<b>DART AEROSPACE LTD</b>	<b>Work Order:</b>	74207
<b>Description:</b> Crosstube Assembly (205/212/412 High Fwd)	<b>Part Number:</b>	D212-664-141
<b>Inspection Dwg:</b> D212-664-141 <b>Rev:</b> D		<b>Page 1 of 1</b>

DRAWING NO. D212-664-141	TITLE XTUBE ASSY (205/212/412 HI FWD)	REV. D	DART AEROSPACE LTD ENGINEERING ORDER		D.E.O. NO. D212-664-141-D-1	SHEET NO. SHEET 1 OF 2	SCALE NTS
DRAWN	CHECKED	MFG. APPR.	APPROVED	DE APPR.			
DATE 11.04.07	DATE 11.07.11	DATE 11.04.12	DATE 11/04/12	DATE 11.04.12

**PURPOSE:**

ADD AN INSPECTION WINDOW TO UNDERSIDE OF CROSSTUBE.

**D212-664-141/-141B  
ASSEMBLY DETAIL**

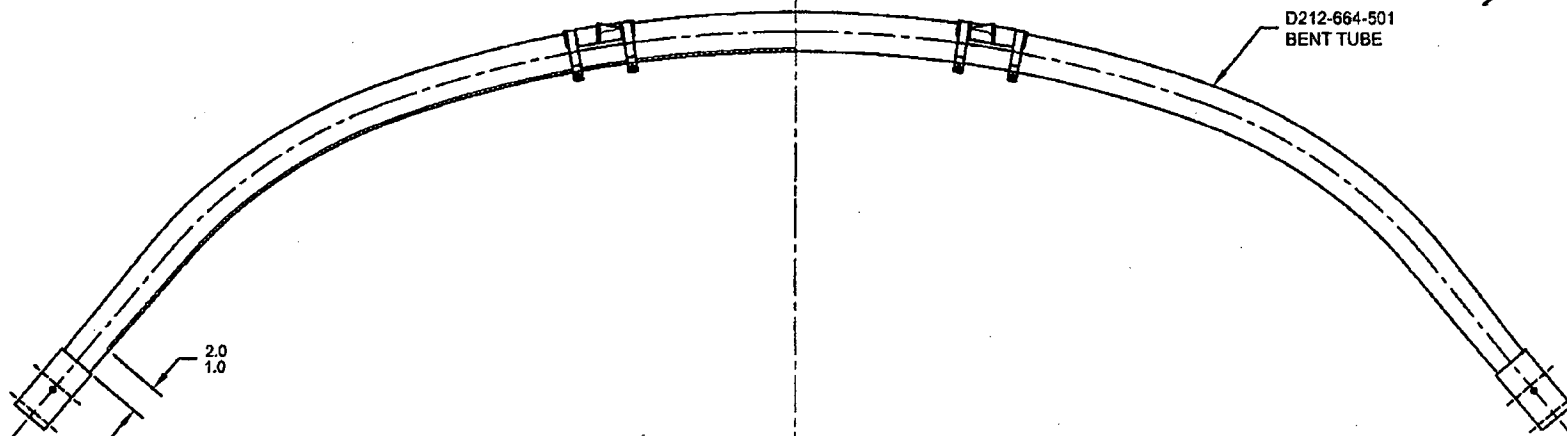
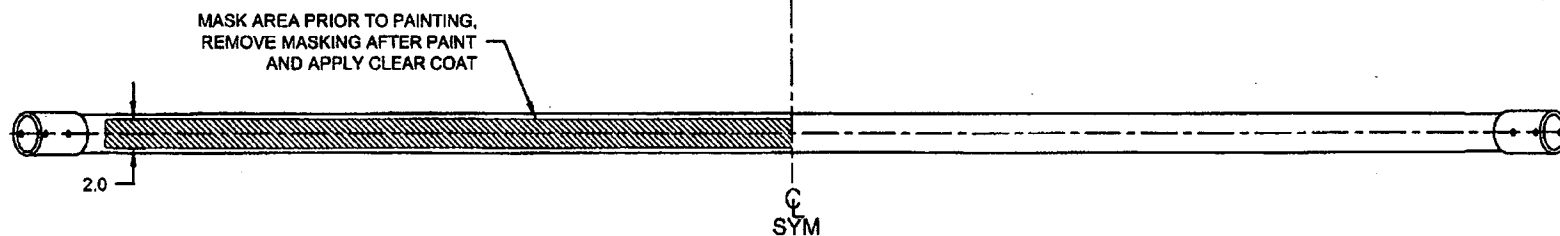
NOTES 2 OF SHEET 1 IS AMENDED AS FOLLOWS:

**IS:**

**WAS:**

- 2) FINISH: CHEMICAL CONVERSION COAT PER DART QSI 005 4.1  
PRIME INSIDE AND OUTSIDE PER DART QSI 005 4.2  
MASK UNDERSIDE OF CROSSTUBE AS SHOWN (HATCHED AREA) AND  
PAINT OUTSIDE PER DART QSI 005 4.2  
REMOVE MASKING AND APPLY CLEAR COAT
